LINCOLN PARK PLANNING COMMISSION

September 13, 2023 at 7 p.m.

Site Plan Review

Applicant	Mohamad Kassem, represented by MA Designers, Inc.
Project	Gas Station Expansion
Address	2575 Dix Hwy, Lincoln Park, MI 48146
Date	September 13, 2023
Request	Conceptual Site Plan Review

A-1

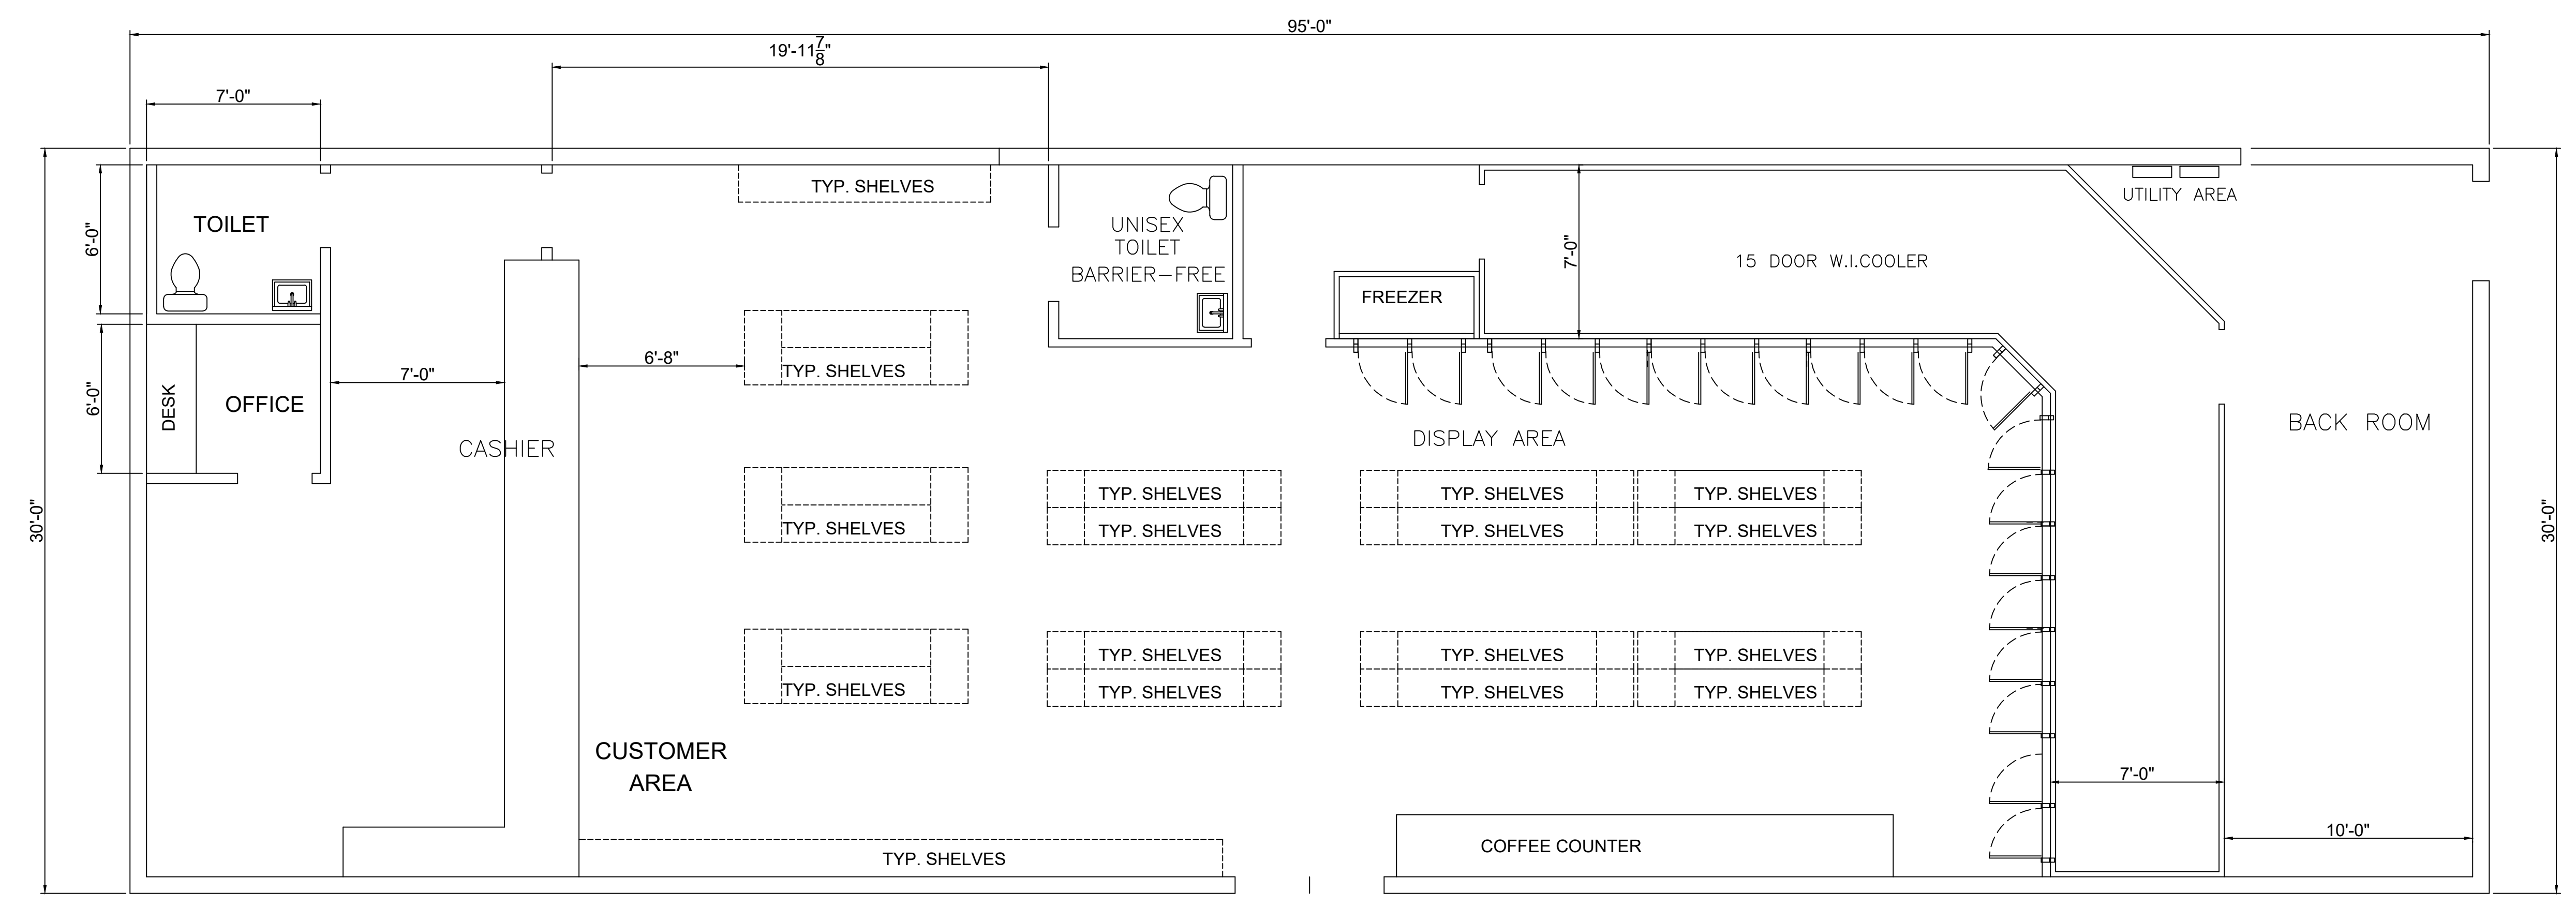
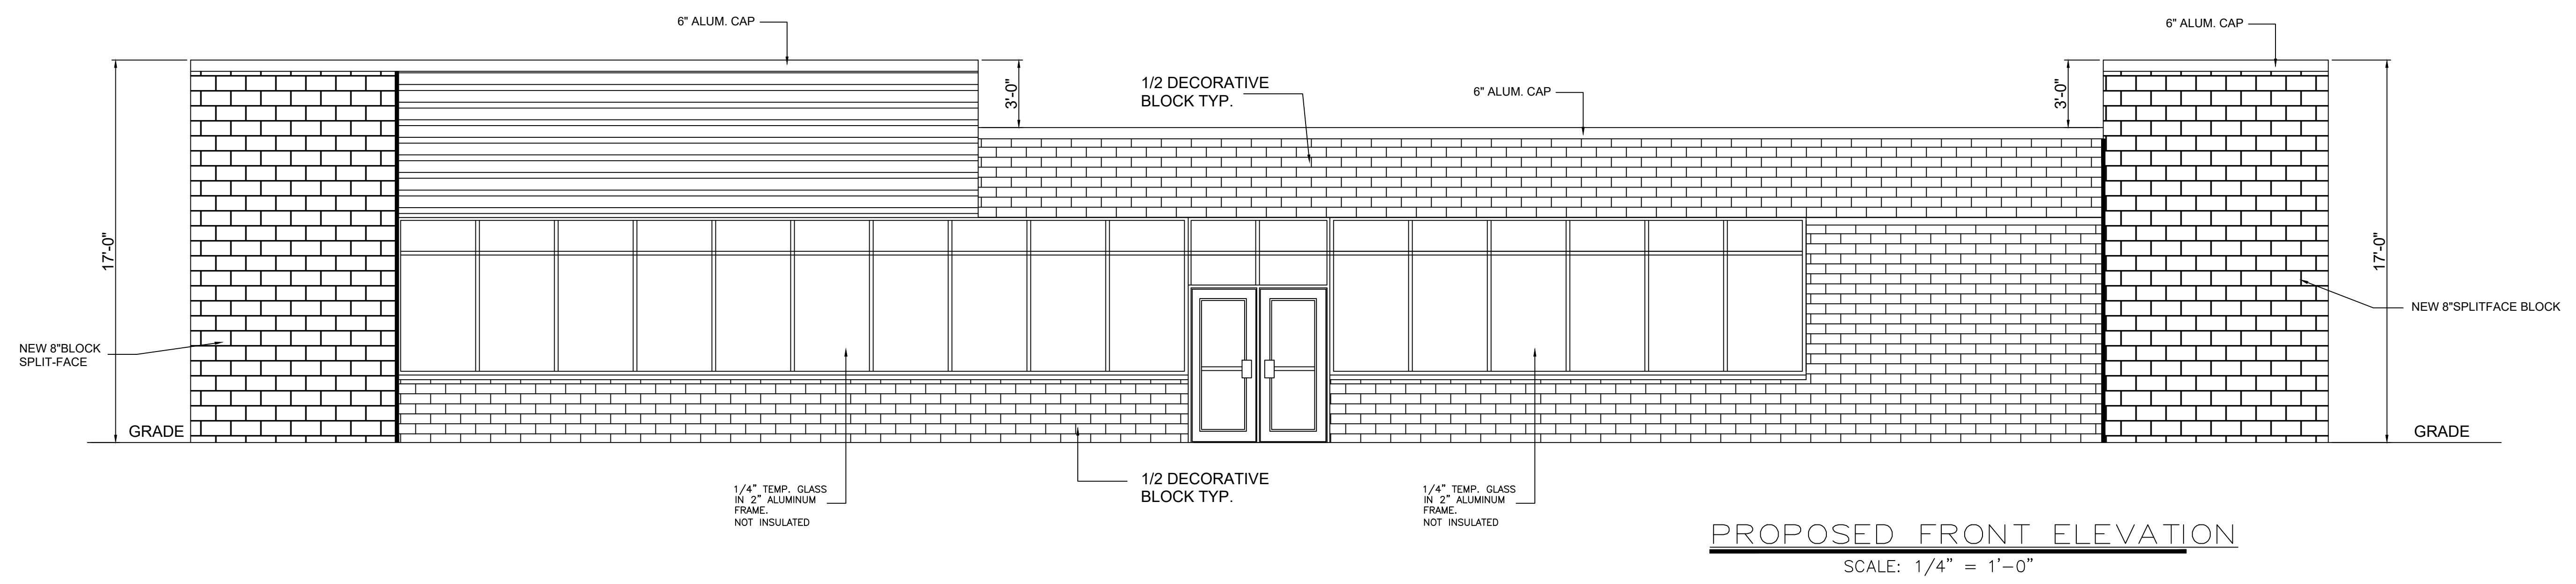
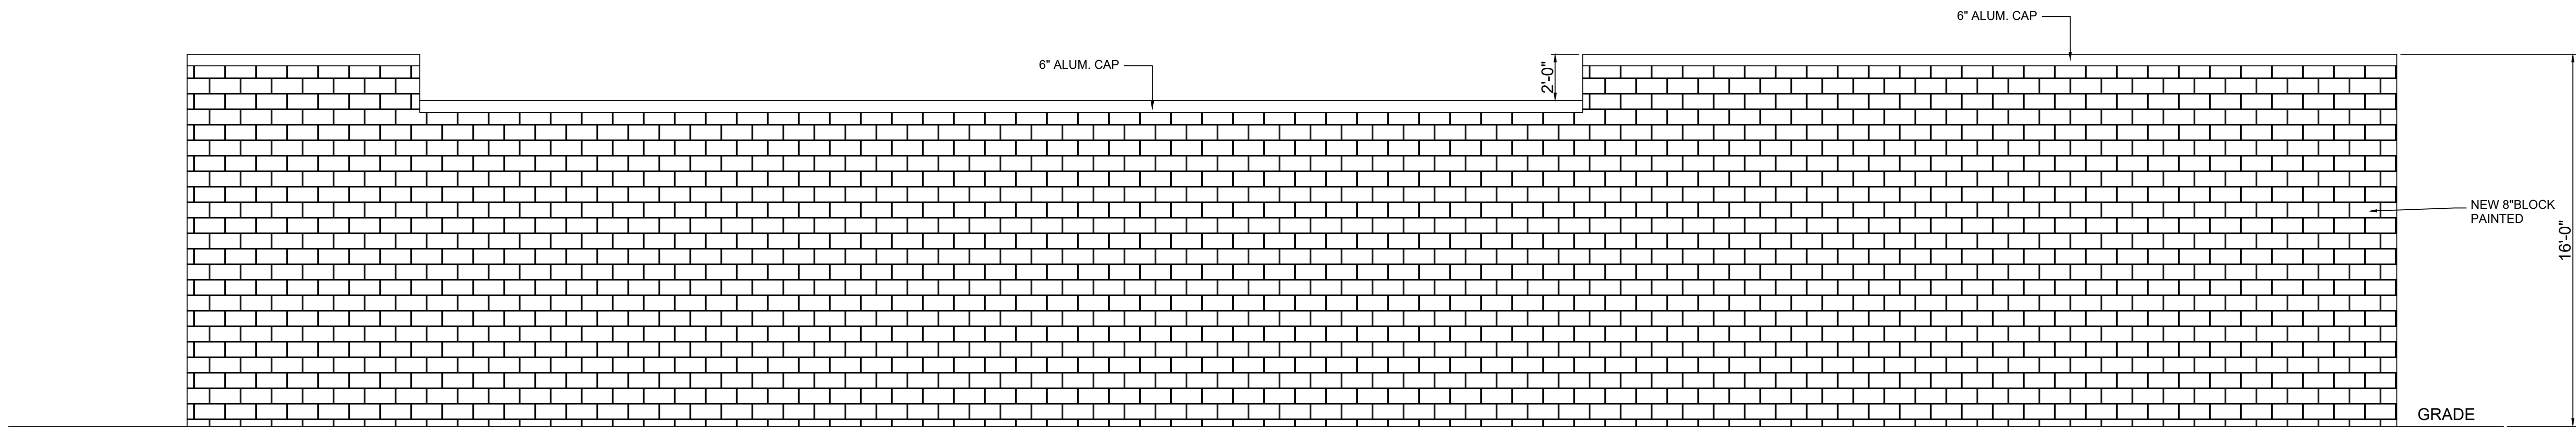
- Applicant shall revise the proposed north and south facades to meet the 25% transparency requirement.*

PROPOSED SITE PLAN
SCALE 1" = 20'-0"

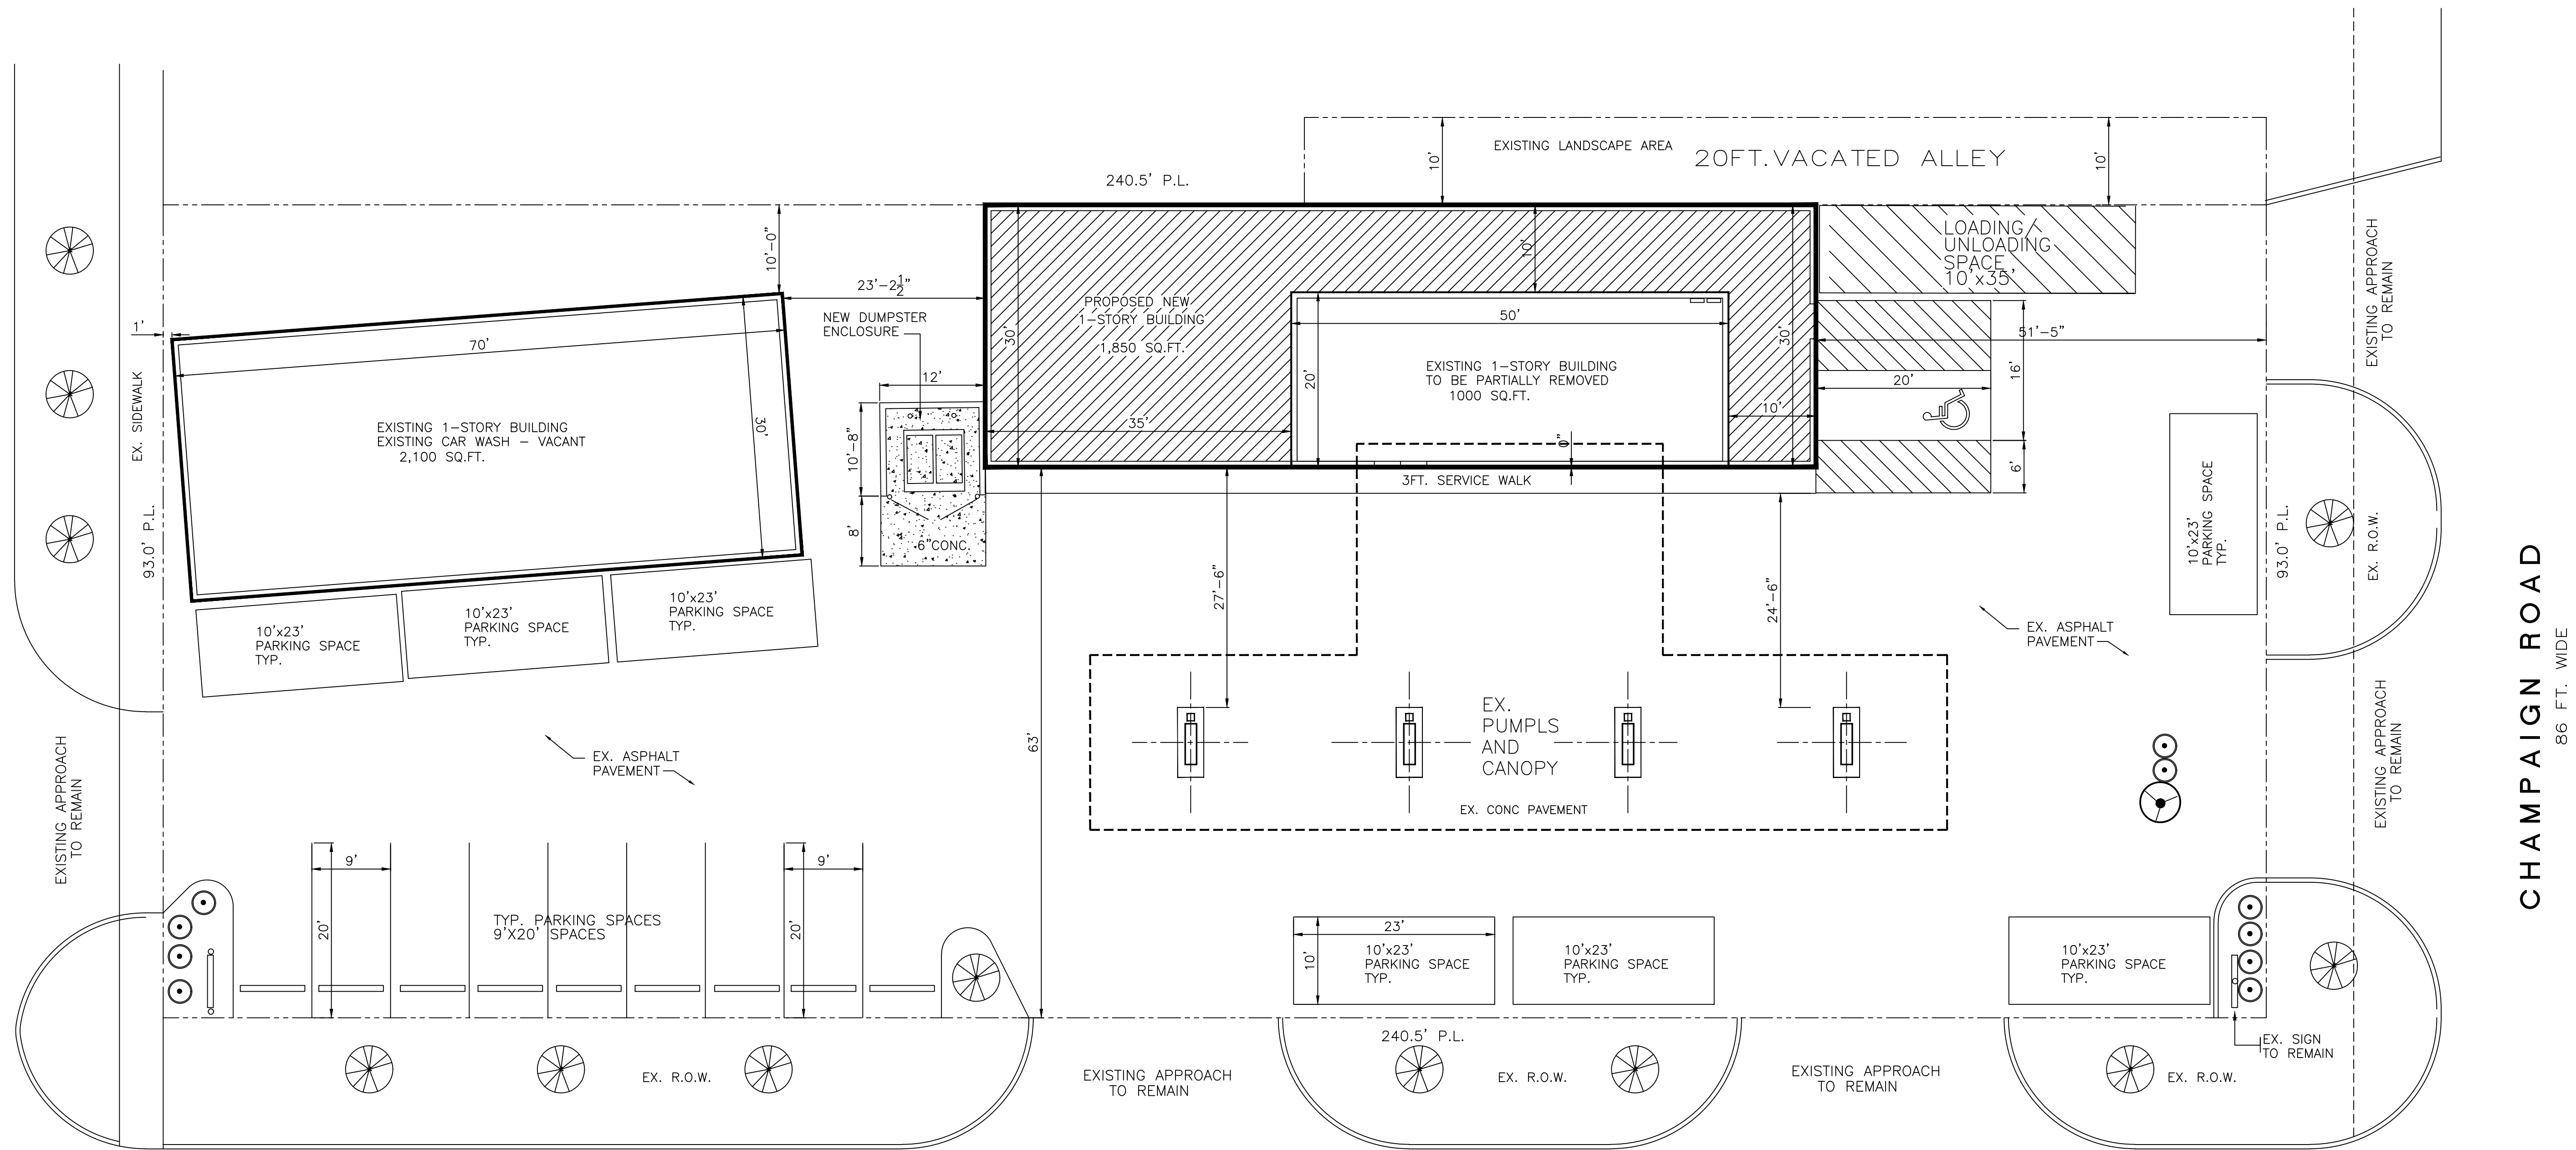
Parking standards are fulfilled, but four of the site's parking spaces pose challenges to safely maneuvering as well as entering and exiting the gas station – cars leaving these spots could pose a danger to cars who are entering along Dix Ave. and Champaign Rd. Removing these spots from the plan will increase the site's safety and room for maneuvering while still meeting the minimum parking requirement. Removing these spots also alleviates the need for curbs to present a barrier along public sidewalks.

- *Applicant shall remove 4 parallel parking spaces – 3 parallel to Dix Ave, and 1 parallel to Champaign Rd. to ensure appropriate maneuvering and safe ingress/egress to site. This removes the requirement for curbs along these spaces that abut public sidewalks.*

Emergency vehicles may access the building via Dix Highway. Engineering comments state that the Lincoln Park Fire Department should review and approve these plans since the new building will prevent traffic from accessing the existing car wash and prevent access to the rear of the building.

- Applicant shall provide additional details on trees that will be planted along the frontage of each street and if there will be greenbelts.
- Applicant shall add an obscuring hedge to shield car lights from the ROW.
- Applicant shall remove proposed landscaping in the driveway on Champaign Road.
